DART AEROSPACE LTD		Work Order:	138495
Description: Crosstube Assembly, Mid Aft		Part Number:	D206-667-247
Inspection Dwg: D206-667-247 Rev: A		Page 1 of 2

DRAWING NO. D206-667-247
TITLE CROSSTUBE ASSY (206L MID AFT)

DRAWING NO. D206-667-247	TITLE CROSSTUBE ASS'Y (206L MID AFT)	REV. A	DART AEROSPACE LTD ENGINEERING ORDER		D.E.O. NO. D206-667-247-A-1	SHEET NO. SHEET 1 OF 1	SCALE NTS
DRAWN <i>qp</i>	CHECKED <i>ASS</i>	MFG. APPR. <i>KB</i>	APPROVED <i>JMP</i>		DE APPR. <i>#</i>		
DATE 11.07.15	DATE 11.07.20	DATE 11.07.21	DATE 11/07/21		DATE 11.07.21

REPLACE MAGNOBOND WITH PROSEAL.

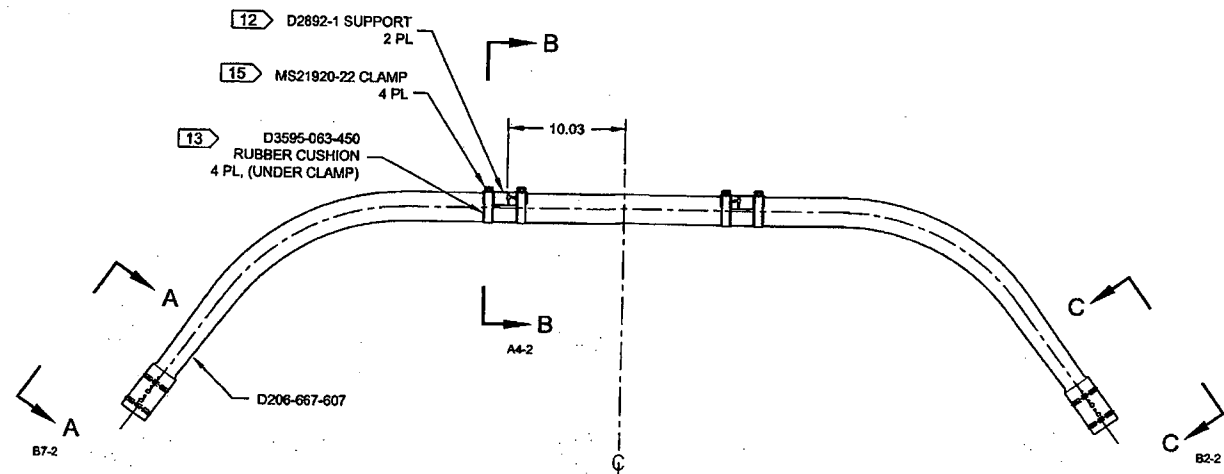
WAS:

9	A/R	MAGNOBOND 6398	ROCKWELL SPECIFICATION RBO-120-023 ADHESIVE (TEXTRON/BELL SPEC. 299-947-100, TYPE II, CLASS 2 ADHESIVE)
---	-----	----------------	---

NOTE 12 & 15, SHEET 1 IS AMENDED AS FOLLOWS:

WAS:

- 12) INSTALL D2892-1 SUPPORT USING 0.03" TO 0.06" THICK LAYER OF MAGNOBOND 6398 PER QSI 015. LET CURE FOR 12 HOURS AFTER INSTALLATION AND PRIOR TO PACKAGING.
- 15) TORQUE CLAMPS 80 TO 100 IN-LB. ENSURE AT LEAST 1.5 THREADS SHOWING IN SAFETY AND THAT NUT HAS NOT BOTTOMED-OUT AFTER TORQUING.

IS:

Item	Qty -247	Part Number	Description
9	A/R	PROSEAL 890 B-2	SEALANT, AMS-S-8802 CLASS B-2

IS:

- 12) TO INSTALL D2892-1 SUPPORT: ABRASE MATING SURFACE OF SUPPORT AND CROSSTUBE WITH 180-GRIT SANDPAPER AND REMOVE RESIDUE WITH MEK (OR EQUIVALENT). APPLY A 0.04" TO 0.07" THICK LAYER OF PROSEAL 890 CLASS B-2 (OR AMS-S-8802 CLASS B-2) SEALANT TO MATING SURFACE OF SUPPORT.
- 15) TORQUE CLAMPS 80 TO 100 IN-LB. ENSURE AT LEAST 1.5 THREADS SHOWING IN SAFETY AND THAT NUT HAS NOT BOTTOMED-OUT AFTER TORQUING. **PRIOR TO PACKAGING, RE-CHECK TORQUE ON CLAMPS AFTER PROSEAL 890 SEALANT HAS CURED FOR 72 HOURS.**
